SUNDRY NOTICES AND REPORTS ON WELLS

Pure Gold D Federal #10 API No. 30-015-35799

Pure Gold D Federal 10 OXY USA Inc. November 14, 2011 Conditions of Approval

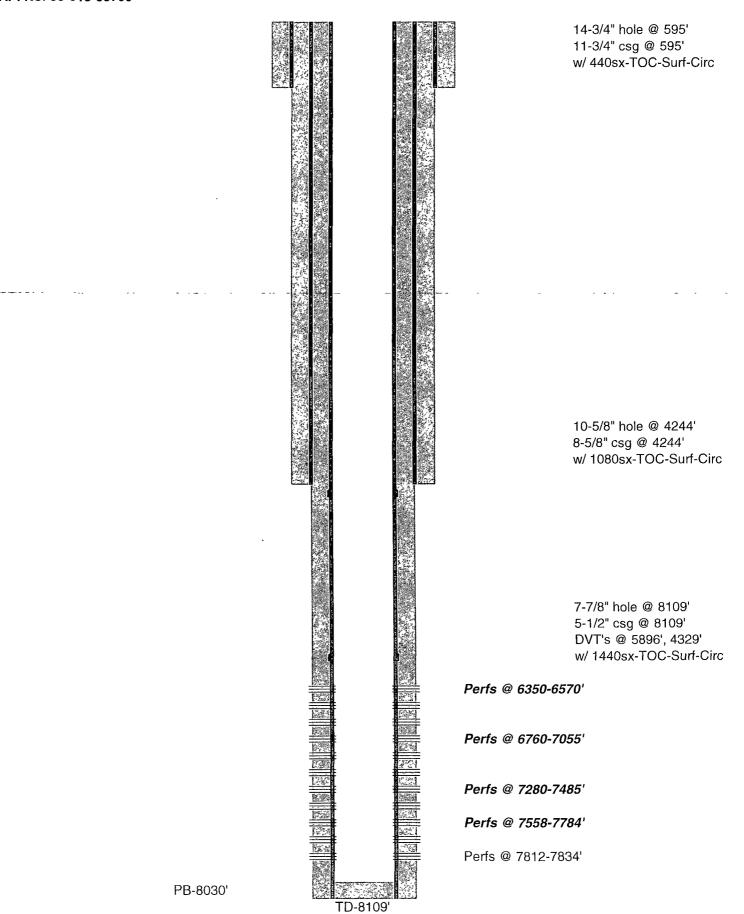
- 6. Operator limited to 3700 psi on the frac down the casing. This is based on 70% of the 5.5" 17# J-55 casing's burst rating.
- 7. Operator to submit a subsequent sundry with details of work performed including a new well test. Due to classification as one pool under order R-10086, no completion report is required.
